Eich Cyf/Your Ref: P/2024/1466

Site Address: LAND AT LOWER BERSE FARM, RUTHIN ROAD, WREXHAM, LL14 4HP

**Site Description: OUTLINE APPLICATION FOR ERECTION FOR 1450 DWELLINGS
(APPEARANCE, LANDSCAPING, LAYOUT AND SCALE RESERVED) AND PROVISION OF
LAND FOR PRIMARY SCHOOL**

Figure 1: A screenshot of the NRW Flood Map for Planning showing the development site. Pluvial flooding is shown in purple and fluvial flooding is shown in blue.

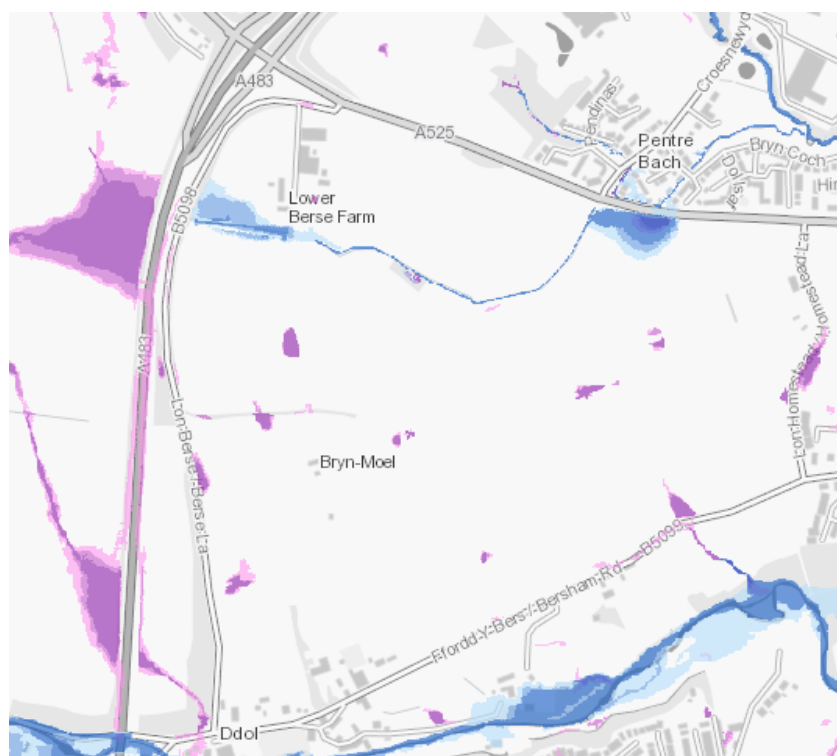
The LLFA appreciates that the Flood Consequence Assessment (FCA) was written before the update to the NRW flood maps in early 2025. However, we will assess the application on the flood map that is available to us at the time of writing this response. Figure 1 shows the current flood risk map for the site including both pluvial and fluvial sources. It is noted by the LLFA that multiple areas of Flood Zone 3 for surface water flooding are present on site. Whilst the LLFA appreciates that the development site will undergo landscaping, we consider that highly vulnerable development should be avoided in these zones. This is due to the testament provided to the LLFA that groundwater resurgence can occur on site and the shallow groundwater encountered by the developers' own infiltration testing.

Figure 3: An overview of the NRW Development Advice Map for Planning for the flooding which occurs to the south west of the proposed development.

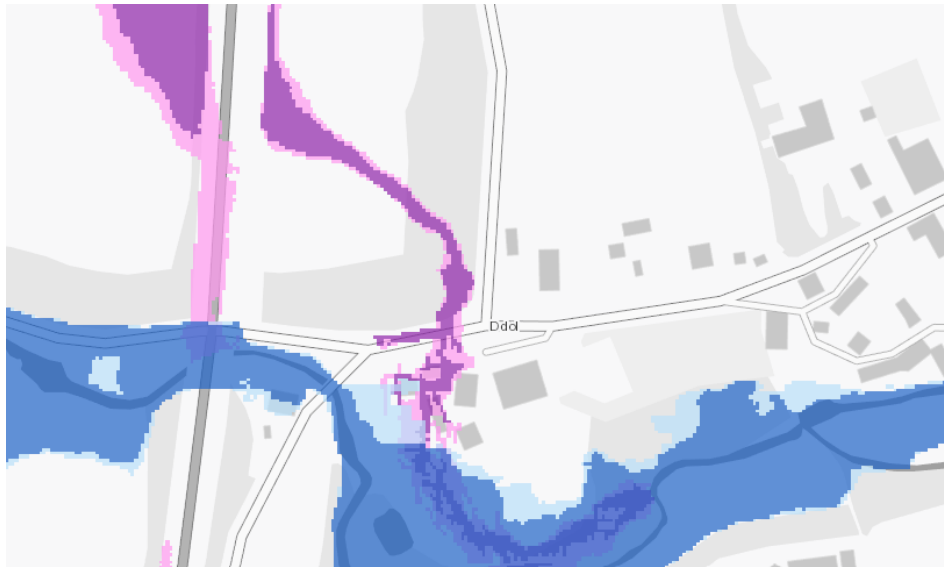
The LLFA has further concerns about flooding to the south west of the development site as further properties are at risk. This flooding is related to the overtopping of an under capacity culvert and siltation in the culvert on land that we believe the developer will be responsible for. When the water overtops, this has been known to travel down the adopted highway and cause internal flooding to existing residential properties. The LLFA believes that an upgrade to this culvert system should be considered as a part of the application and that a flood storage area should be created. However, even if this upgrade were to occur, the **LLFA would object to any further discharge of water into this culvert beyond a restricted greenfield runoff rate.**

Figure 4: An extract from the NRW Development Advice Map showing flooding in the vicinity of Lower Berse Farm.

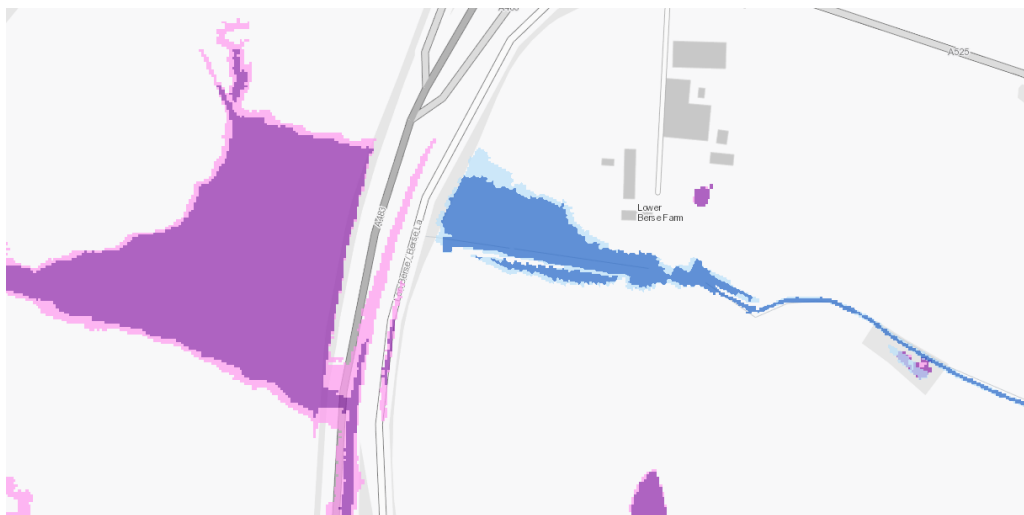
Finally, the LLFA would like to draw the attention of the LPA to flooding on the north eastern side of the development. It is understood that this area of the development will be the likely location of Development Parcel H and the associated attenuation pond. The LLFA would request that any development and associated drainage infrastructure is also avoided in the area outlined as a flood zone in the above figure. This is because the connectivity of drainage into the site from the nearby trunk road, the A483, is not well understood and the existing culvert near to Lower Berse Farm is believed to be under capacity. **It is the opinion of the LLFA that the connectivity here should be better understood before the development can obtain outline planning permission** and the ability of the ordinary watercourse to access a flood plain is preserved. It observed by the LLFA

that no changes are proposed to the existing culvert under Lower Berse Farm despite potential capacity issues.
